**City of Sparks
Planning Commission Item**

Subject: PCN18-0057 – Consideration of and possible action on a request for a Conditional Use Permit for a Major Recreational Facility (an outdoor concert amphitheater) on a site approximately 2.25 acres in size in the MUD (Mixed Use District – Downtown/Victorian Square) zoning district located at 1040 Victorian Avenue, Sparks, NV. (For Possible Action). *This item was continued from the December 6, 2018 Planning Commission meeting*

review, conducted by Bollard Acoustical Consultants, Inc., is attached (Exhibit B – City’s Peer Review of Sound Analyses, referred to hereafter as the “Peer Review”).

Figure AS The “A” weighting network; low frequency sound energy is rolled off

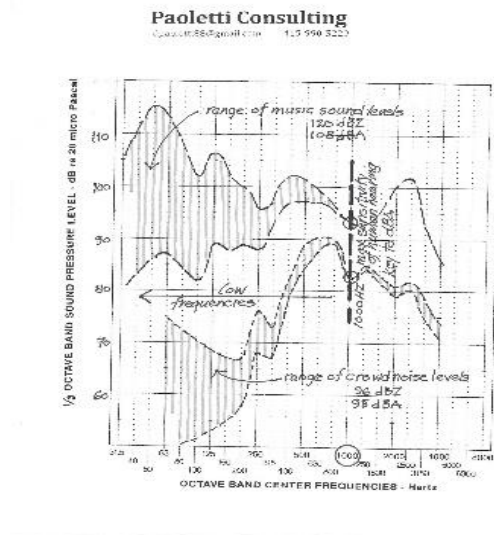
Figure AS of the Paoletti report is illegible and should be presented as a full page graphic. While BAC agrees that concert sound systems generate sound with considerably more low-frequency content than ambient conditions, the source of the data presented in Figure AS should be provided.

Figure SPMP Measurement positions

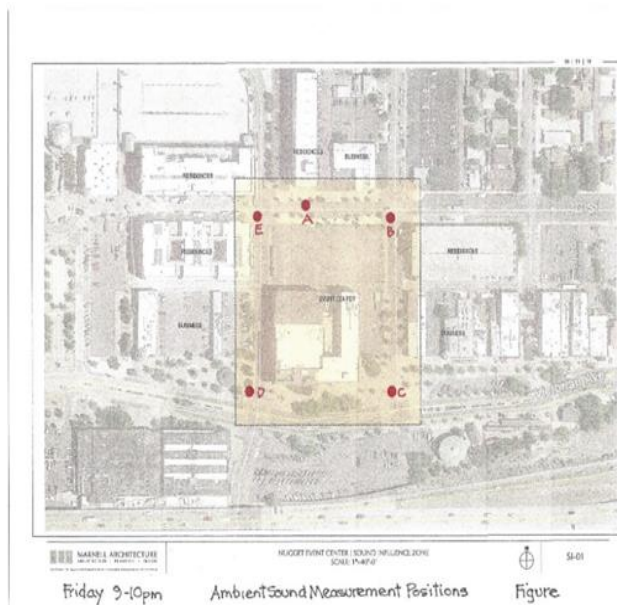
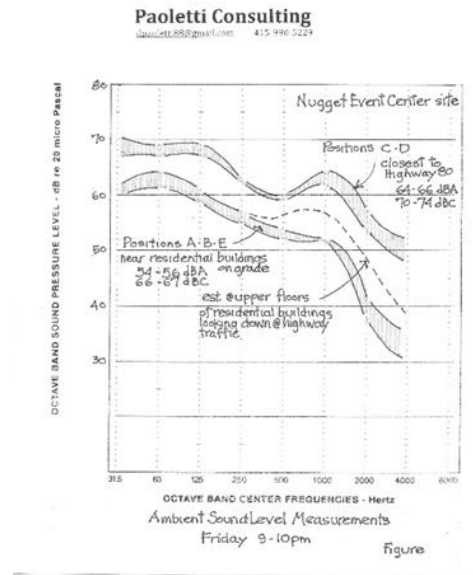
Figures SPMP and SMR are difficult to read due to low resolution. In addition, it is unclear if the ambient noise measurement results shown in Figure SMR are presented in terms of A-weighted or linear levels. Given the reported levels of 54-56 dBA in the first paragraph on Page 5, it appears that the ambient surveys were conducted to capture A-weighted sound levels (as is appropriate). However, the frequency data shown on Figure SMR indicates linear levels. A simple table depicting the time, duration, and measured L_{eq} , L_{max} , and L_n values of the ambient noise surveys would be helpful.

Figure ISL Interior sound level residential unit

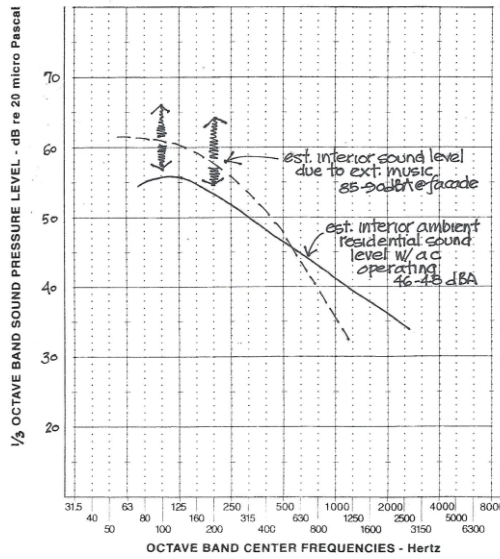
Figure ISL indicates that the estimated noise level due to music would be approximately 85-90 dBA at the exterior façade. As noted previously, however, exterior noise levels at the nearest residential building façades would be 92 to 99 dBA, which is considerably higher than the levels shown in Figure ISL. In addition, there is insufficient support for the conclusions reached in the Paoletti report from the use of Figure ISL. For example, at 500 Hertz, Figure ISL appears to indicate that interior noise levels resulting from exterior music would essentially equal interior ambient noise levels resulting from air conditioning systems. This conclusion is incorrect.

Figure 5A Amplified music at 100 dBA plus 50% crowd noise

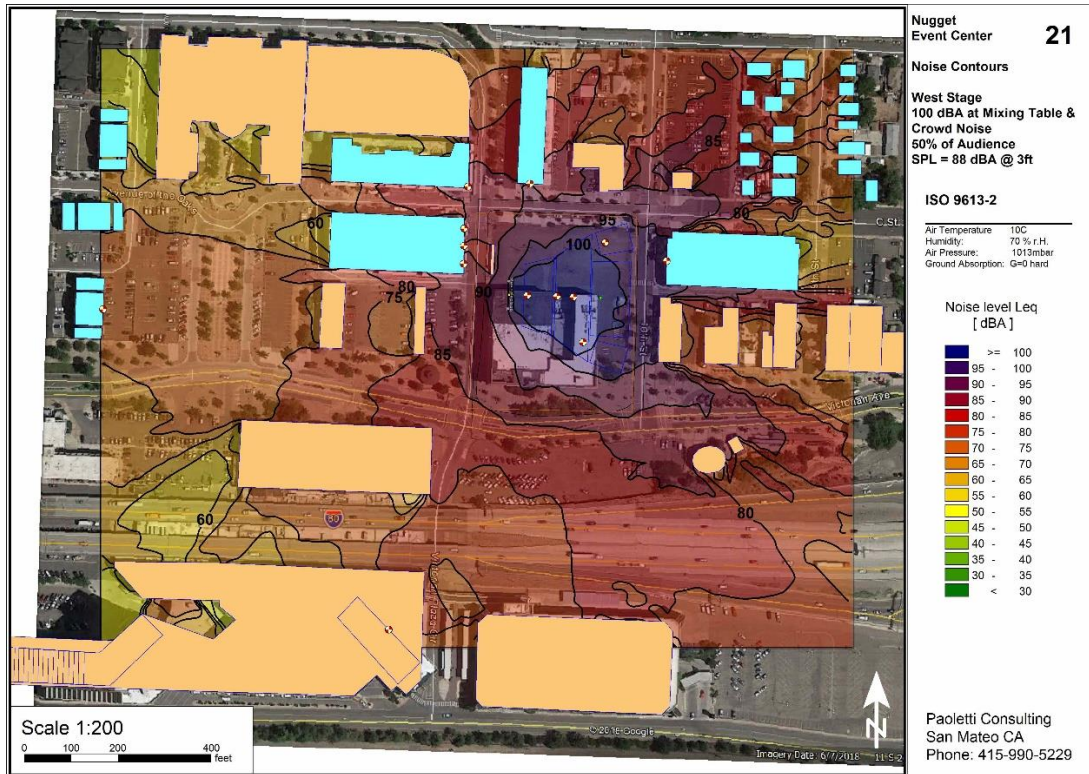
Using the BAC projections of noise from a typical headliner act (100 dBA average at mixing booth), the noise levels at the nearest residential building façade to the west are predicted to be closer to the Figure 5A results than the results presented in the Executive Summary. Specifically, it is BAC’s professional opinion that average and maximum noise levels at the nearest building façade will be 92 and 99 dBA, respectively, which is 7 to 9 dB louder than the levels presented in the Paoletti Executive Summary.

The Paoletti Report should be revised to reflect that noise levels at the nearest residential building facades to the west would be more representative of the noise levels reported in Figure 5A of the Paoletti Report.

Figure 1

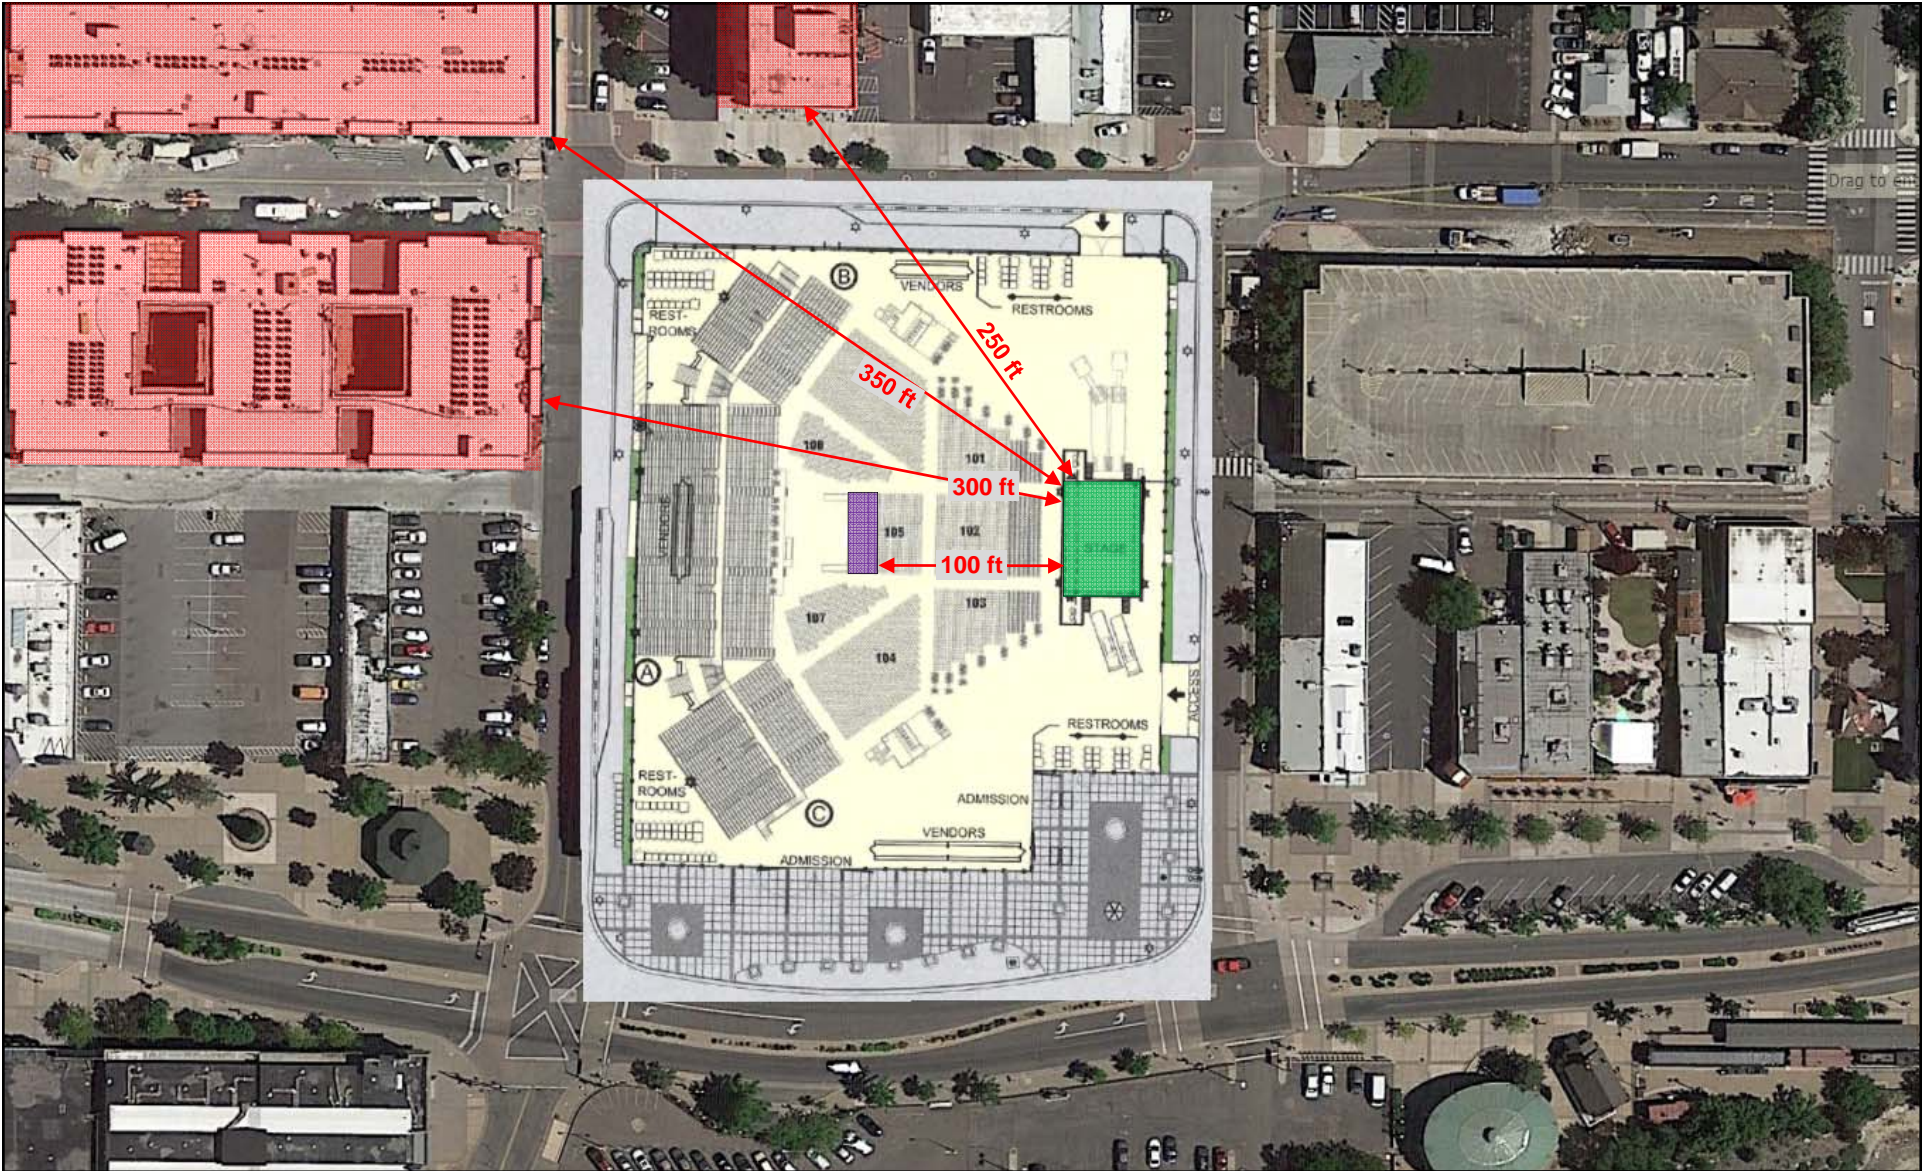
The project description provides an adequate discussion of the proposed use, but Figure SP is of insufficient scale and resolution to make the information contained in the legend readable. See Figure 1 of this letter for a more clear site plan.
